REMARKS

ANNOTATED SHEET SHOWING CHANGES

ADDED Fig. 2

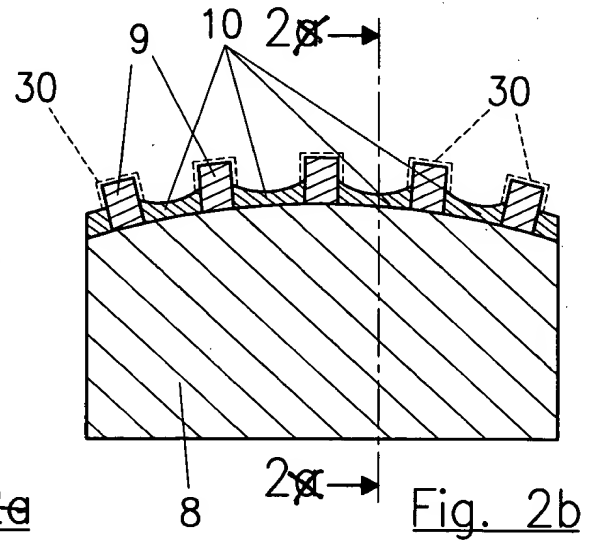
In response to the enablement rejection, Applicant submits with this response a Declaration by Ulrich Bingel, a person skilled in the art, pursuant to 37 C.F.R. §1.132. The Examiner first refers to the original-filed Fig. 2 and disclosure at pg. 6, Ins. 30-34 and states it would appear (presumably referring to Fig. 2) that the positioning of the plurality of optical elements (mirrors) on the basic body would prevent an intermediate layer from being formed between the basic body and the individual optical elements during the galvanoplastic joining technique (pg. 3 of paper no. 20040321). **Please note**, respectfully, the intermediate layer 10 is not formed in a stacked configuration with the basic body 8 and optical elements 9. That is, the optical elements 9 are on and “touch” the basic body 8 as clearly stated by the originally-filed application and explained by Ulrich Bingel (paras. (b)-(g) of the Declaration). Ulrich Bingel makes it clear that one skilled in the art would not interpret Fig. 2 and the disclosure at pg. 6, Ins. 30-34 in the manner presented by the Examiner, and

Please further note, Fig. 2 clearly illustrates basic body 8 and intermediate layer 10 as being hatched, that is, with **hatch lines** while optical elements 9 **are not** hatched. That is, the sectional view of Fig. 2 has the hatched portions of basic body 8 and intermediate layer 10 in the same plane of the page, while optical elements 9, since not being hatched, are illustrated **behind** the plane of the page. Accordingly, the originally-filed Fig. 2 clearly illustrates that basic body 8, intermediate layer 10 and optical elements 9 are not arranged in a stacked orientation, but are oriented, from the Fig. 2 view, with the intermediate layer 10 in front of the illustrated optical element 9. As Ulrich Bingel explains, one skilled in the art understands the arrangement from viewing Fig. 2. This arrangement is also shown in Fig. 2b as a side view of Fig. 2.

Moreover, the Examiner states it would appear (again presumably referring to Fig. 2) that the positioning of the plurality of optical elements (mirrors) on the

The drawings are objected to wherein the Examiner alleges newly added Figs. 2a and 2b are new matter. The drawings are amended to cancel Fig. 2a. Applicant traverses the objection to Fig. 2b which is explained more thoroughly below. Moreover, the drawings are amended to again include the originally-filed Fig. 2. Since Fig. 2 was filed with the originally-filed application, no new matter is added.

that one skilled in the art understands that intermediate layer 10 is on portions of basic body 8 between respective optical elements 9 (paras. (b)-(g) of the Declaration).

basic body would result in substantially covering all exterior surfaces of the optical elements during the galvanoplastic joining technique (pg. 3 of paper no. 20040321). As Ulrich Bingel explains, one skilled in the art knows how to avoid inadvertently covering optical elements by galvanic deposits (Declaration at para. (h)). Moreover, Applicant submits that it is well known and understood how to remove material from over a substrate, such as galvanic deposits over optical elements. This is further evidence that the claims are enabled.

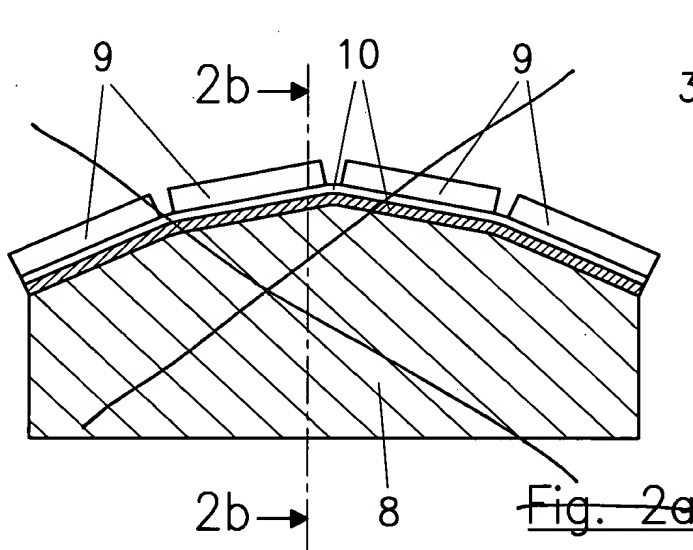
The amendment filed February 23, 2004 is objected to under 35 U.S.C. §132 for allegedly introducing new matter into the disclosure, particularly referring to the disclosure addressing previously added Figs. 2a and 2b. The disclosure directed to Fig. 2a is cancelled. Applicant traverses the objection to Fig. 2b which is explained more thoroughly below, and therefore, the disclosure to Fig. 2b remains.

Regarding Fig. 2b, Applicant submits such illustration is inherent from the originally-filed disclosure, including Fig. 2. Further evidence of the inherency of Fig. 2b with respect to Fig. 2 is demonstrated by the Declaration at, for example, para. (g). Applicant submits since Fig. 2b is inherent from the originally-filed application, the objection against Fig. 2b and the objection to portions of the specification directed to Fig. 2b are inappropriate and should be withdrawn.

Moreover, the objection to Fig. 2b is inappropriate since such figure is inherent from the originally-filed disclosure, including Fig. 2. Accordingly, the objection against Fig. 2b and the objection to portions of the specification directed to Fig. 2b are inappropriate and should be withdrawn.
